CARDS 0 & 1, MODULE CTAXF133 @12W
INSTALLED 3-14-23 REMOVED 3-21-23
BEFORE TERMINATION MODIFICATION

TERMINATION MODIFICATION

BUNCH FIXED AMPLIFIER

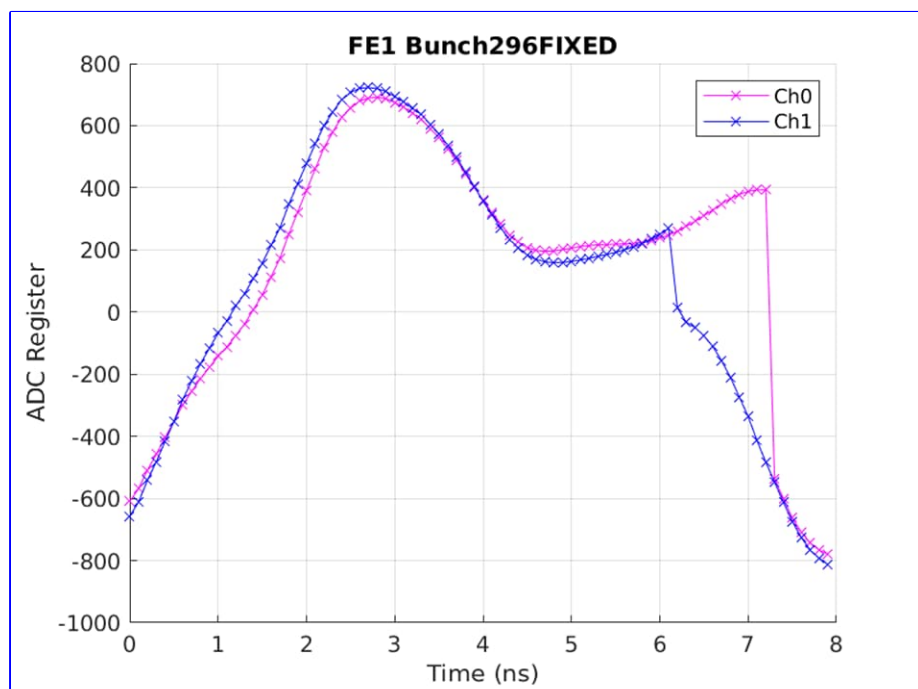
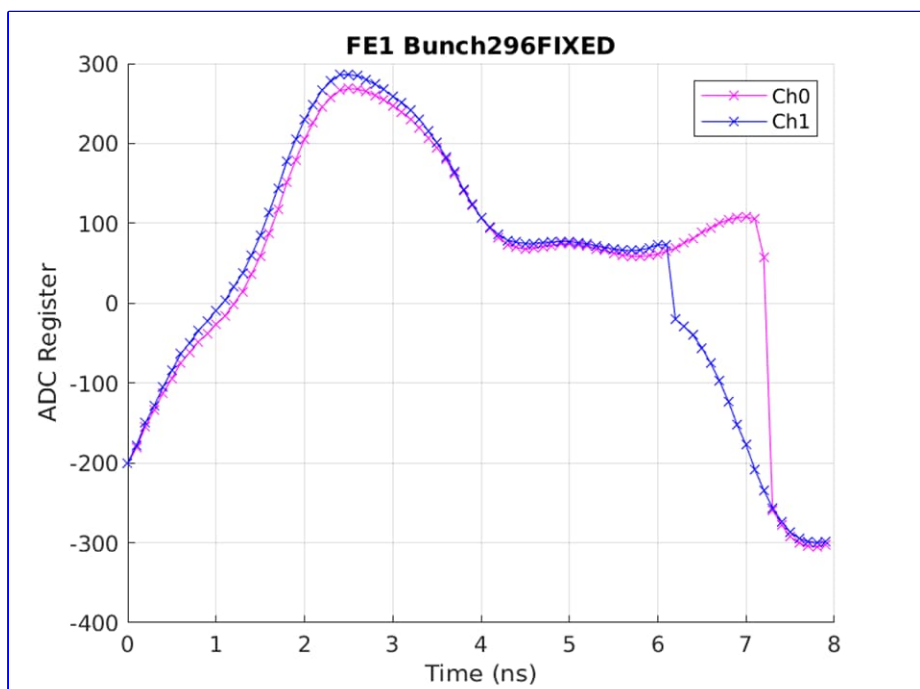
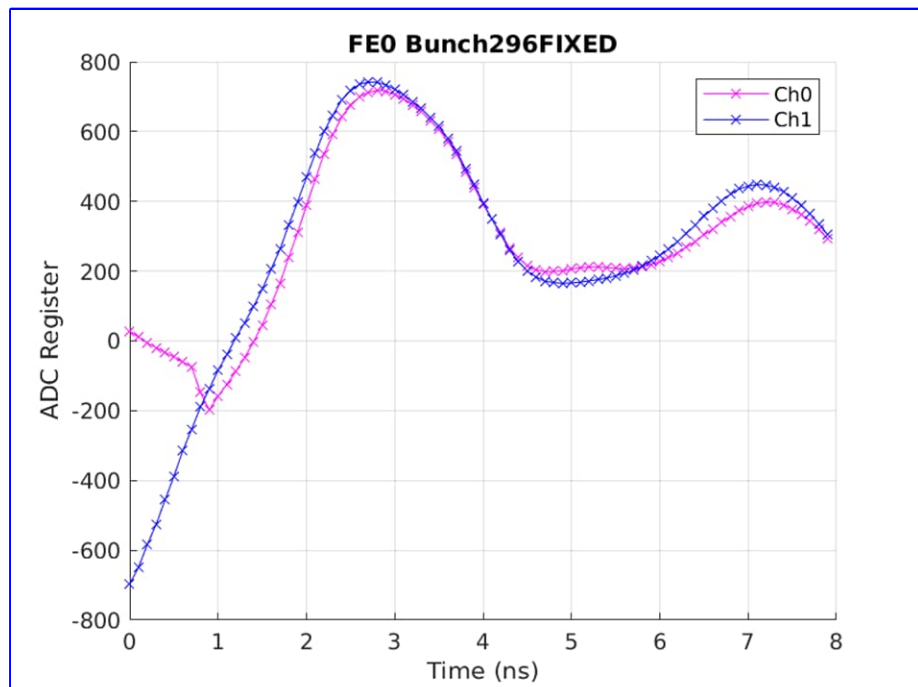
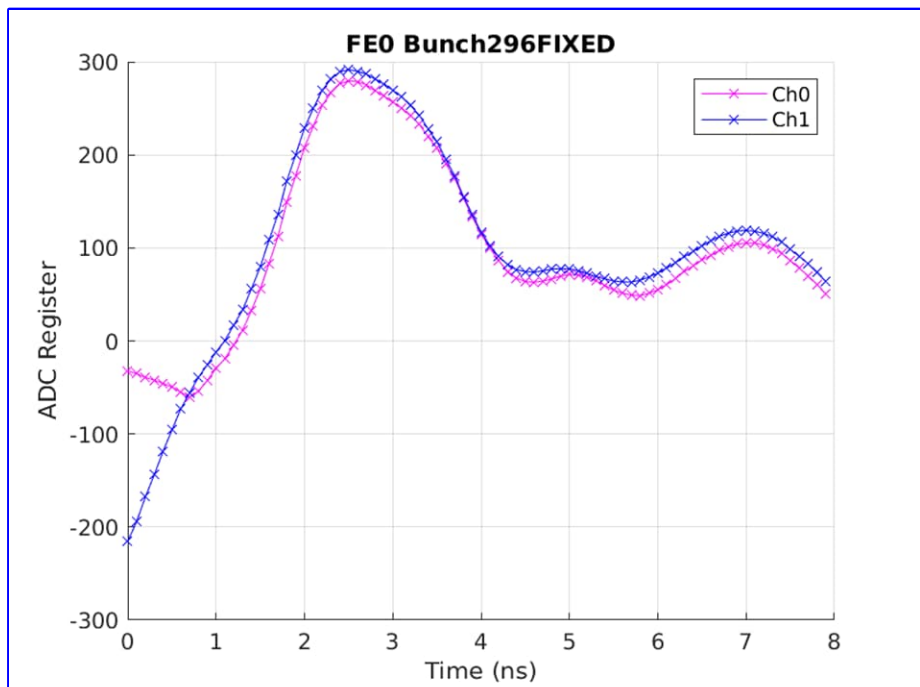
CARDS 0 & 1, MODULE CTAXF133 @12W
INSTALLED 3-14-23 REMOVED 3-21-23
BEFORE TERMINATION MODIFICATION

CARDS 0 & 1, MODULE CTAXF133 @12W
AFTER TERMINATION MODIFICATION
ON 3-21-23

1. Remove: R67 49.9 ohm (extra termination)
 Replace: DNP
2. Remove: R63, R66, R68 16.9 ohm (6dB attenuator)
 Replace: 0 ohm jumper
3. Remove: R58, R84 49.9 ohm (excess termination)
 Replace: 100 ohm
4. Remove: R72, R96 49.9 ohm (extra termination)
 Replace: DNP
5. Remove R71, R75, R94, R98 33 ohm (excess termination)
 Replace: 100 ohm

VARIABLE AMPLIFIER LOW GAIN

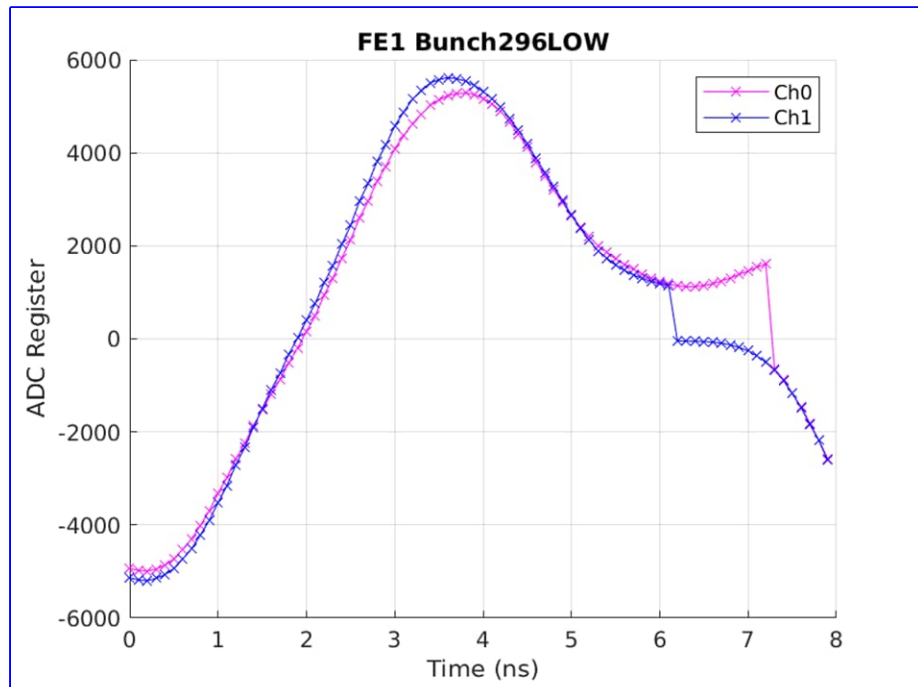
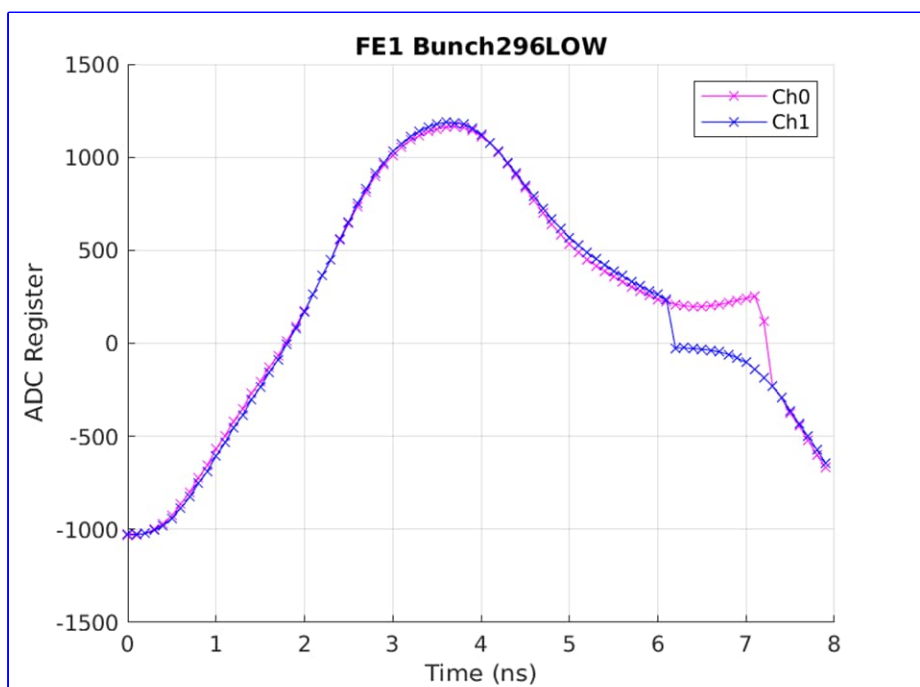
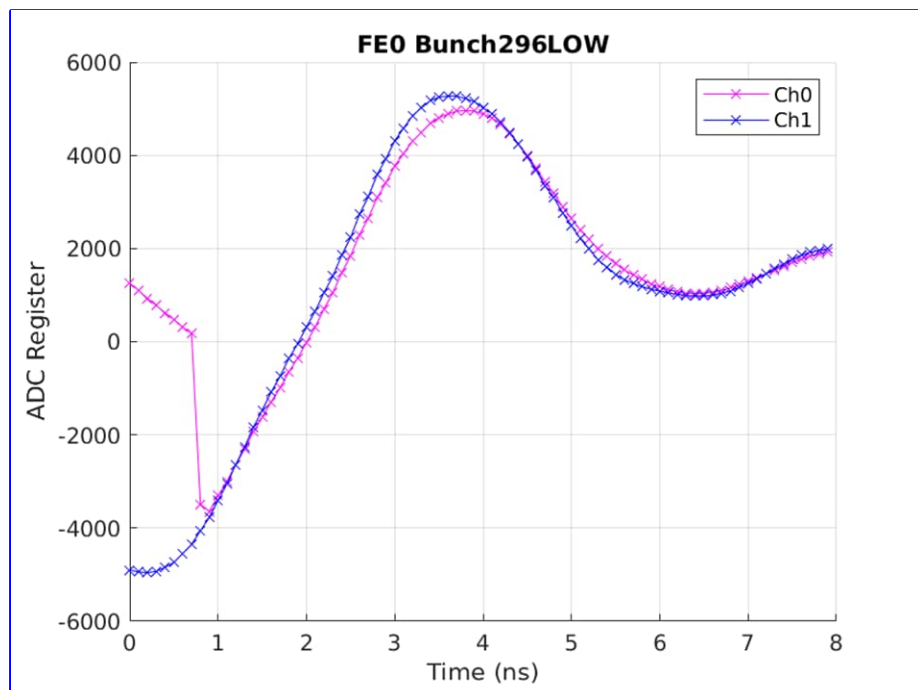
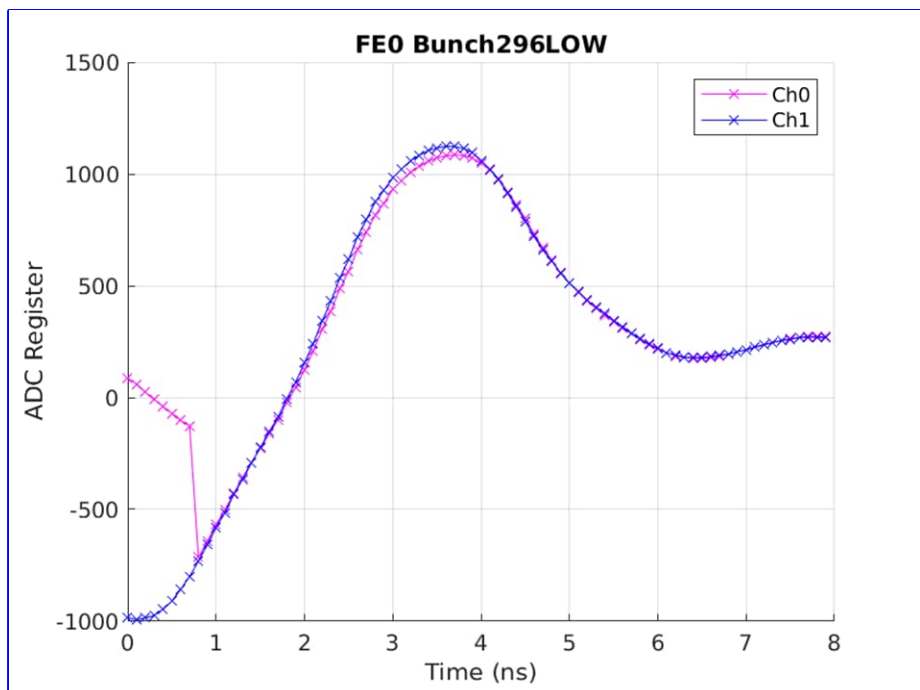
CARDS 0 & 1, MODULE CTAXF133 @12W
 INSTALLED 3-14-23 REMOVED 3-21-23
 BEFORE TERMINATION MODIFICATION

BUNCH HIGH GAIN AMPLIFIER

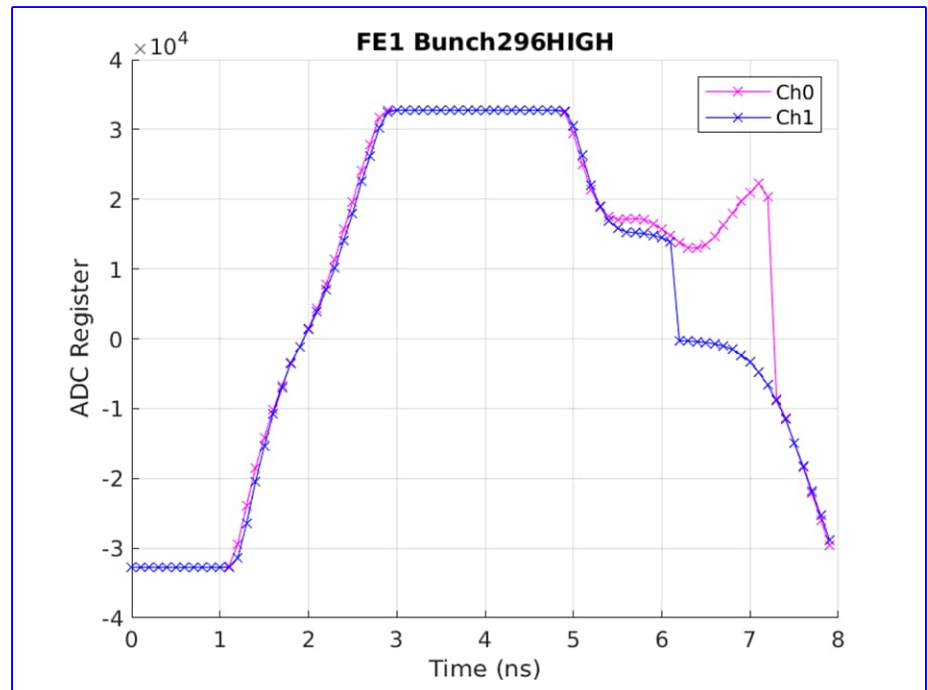
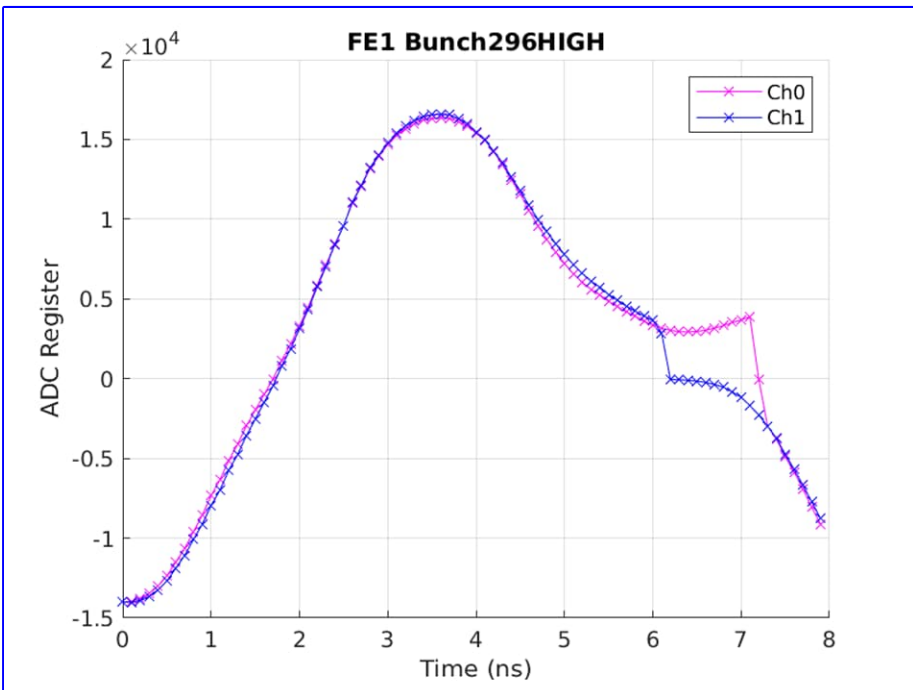
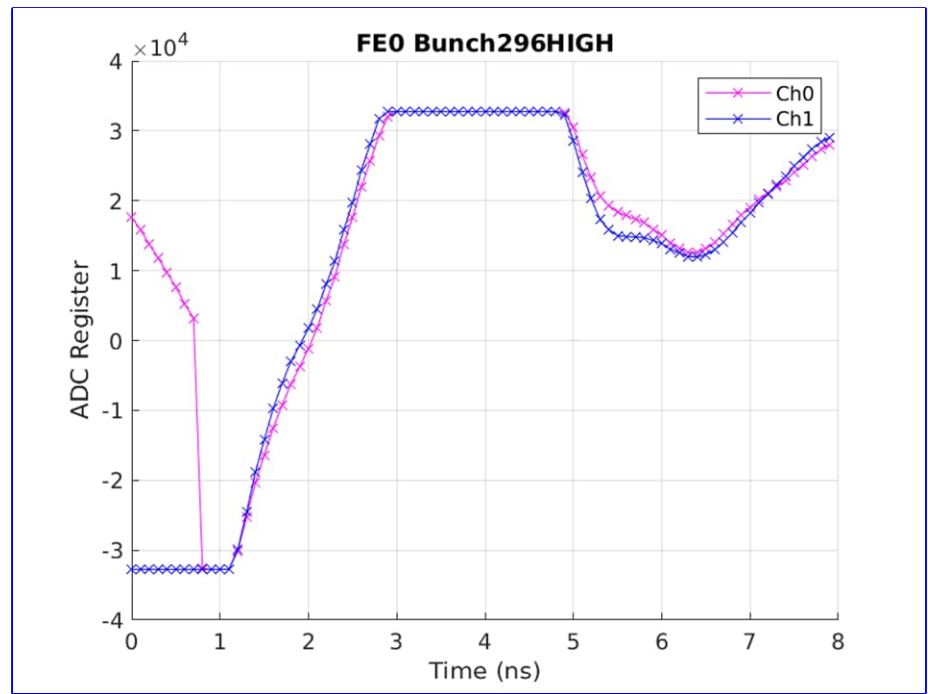
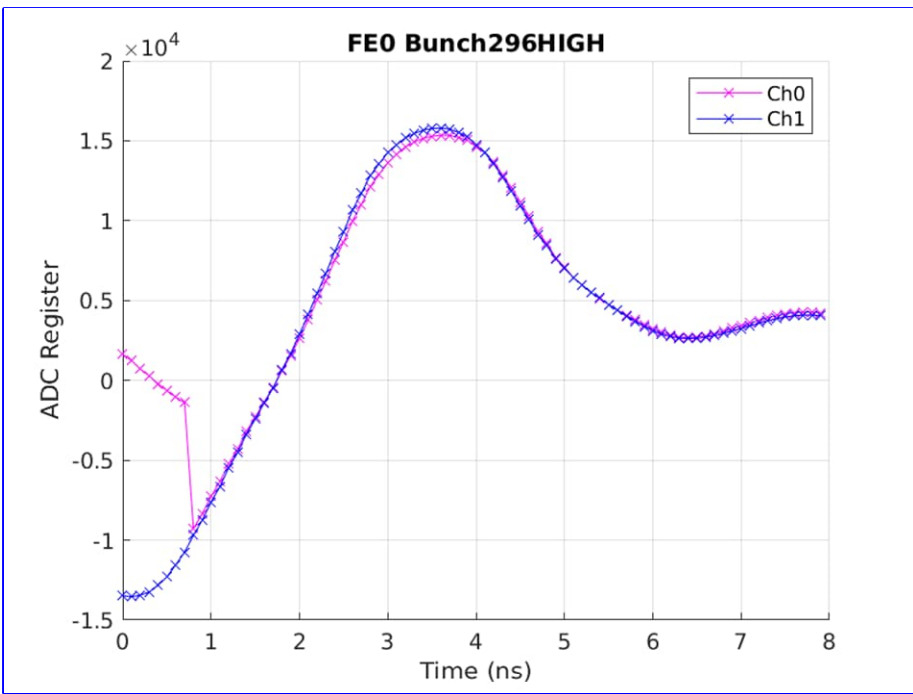
CARDS 0 & 1, MODULE CTAXF133 @12W
 AFTER TERMINATION MODIFICATION
 ON 3-21-23
